Responses to USEPA 6/23/12 TSCA-Related Questions

PROJECT
NEW BEDFORD
MARINE COMMERCE
TERMINAL

SHEET TITLE
STORMWATER DRAINAGE SWALE MITIGATION AREA VORONOI CELL DISTRIBUTION

DRAWING NO.
V-5.3

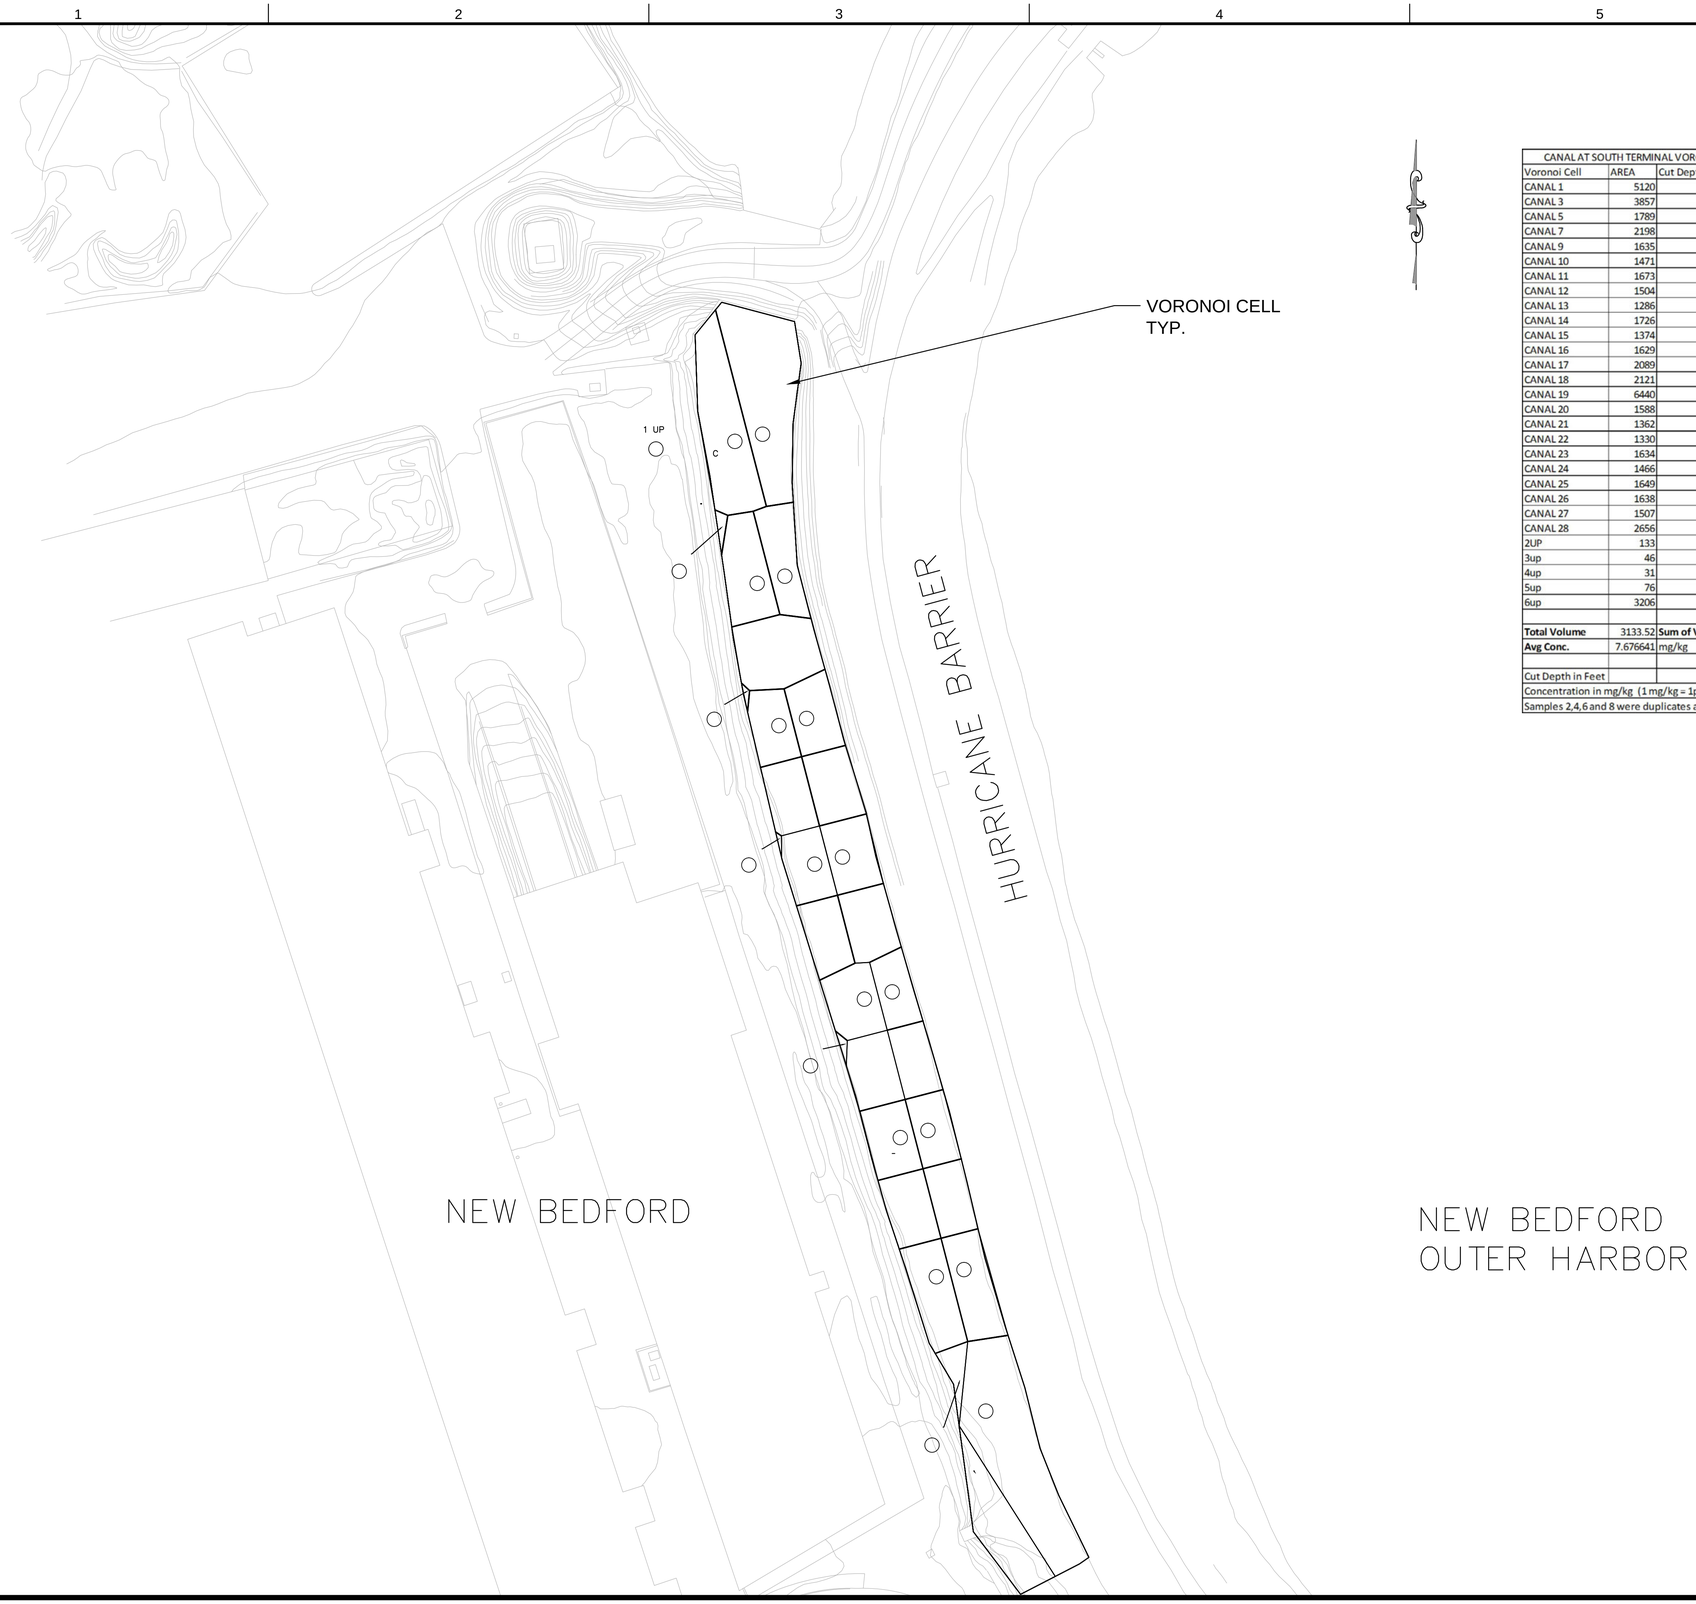
1. **Question:** *What is the current proposed management of the drainage swale sediments? Is it still proposed to manage these sediments in CAD-2? If so, how does the concentration of all cocs in the drainage swale sediments compare to the cocs concentrations in the harbor sediments that will be dredged during the ST project?*

Response: The Commonwealth currently anticipates that the drainage swale sediments will be placed into CAD Cell #2. The Constituents of Concern in the Stormwater Drainage Swale Mitigation Area are generally higher in concentration than other sediments to be dredged associated with the New Bedford Marine Commerce Terminal; however, please note that the New Bedford Marine Commerce Terminal sediments are to be placed within CAD Cell #3. The concentrations of Constituents of Concern in the Stormwater Drainage Swale Mitigation Area are generally the same or lower than the concentrations of Constituents of Concern for other sediments that have previously been dredged during the Phase III Navigational Dredge project under the State Enhanced Remedy process and placed within CAD Cell #2. A drawing showing the concentration of PCBs within the Stormwater Drainage Swale Mitigation Area as well as the average concentration of PCBs (7.67 mg/kg) for sediments within the Stormwater Drainage Swale Mitigation Area as well as a summary of the material that has historically been placed within CAD Cell #2 is included as **Attachment A.**

Analytical data for samples collected within the Stormwater Drainage Swale Mitigation Area (including samples collected below Mean High Water, labeled "CANAL" and samples collected above Mean High Water, labeled "UP") is contained within Appendix 73 of the Commonwealth's January 18, 2012 submittal to EPA. Please note that a report from 2007 was also included within Appendix 73 of the Commonwealth's January 18, 2012. Conversations with EPA personnel have indicated that there is some confusion regarding the object and content of this report, in particular the pictures associated with the report. The photos contained within this document are not indicative of the section of the Stormwater Drainage Swale under consideration for mitigation. The area under consideration is only the area between Cove and Gifford Street. Although one photograph (the bottom photograph on the second page) shows the southern portion of that area at a distance, none of the photographs are wholly representative of the area. The existing conditions of the area in question is best represented by the cross-section on Figure 16 of the Commonwealth's January 18, 2012 submittal to EPA.

The cross-section in question shows the hurricane barrier to the far right, an area that is generally flooded immediately to the left of the hurricane barrier, a rip-rap slope to the left of the flooded area, and an upland portion to the far left. Dredging and disposal of dredge materials into CAD Cell #2 is currently planned for material within the flooded area shown in the cross-section ("CANAL" material). Material above Mean High Water ("UP" material) will be excavated and disposed of off-site. Should additional samples
